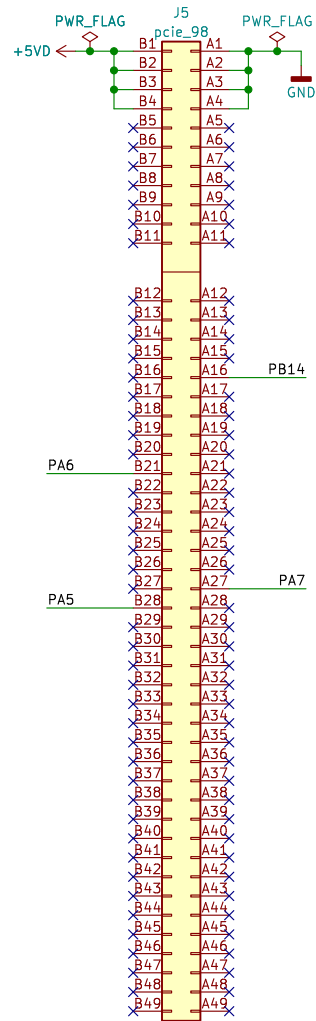
TODO: consider to move the thermistor inputs to a seperate board due to ADC internal crosstalk.
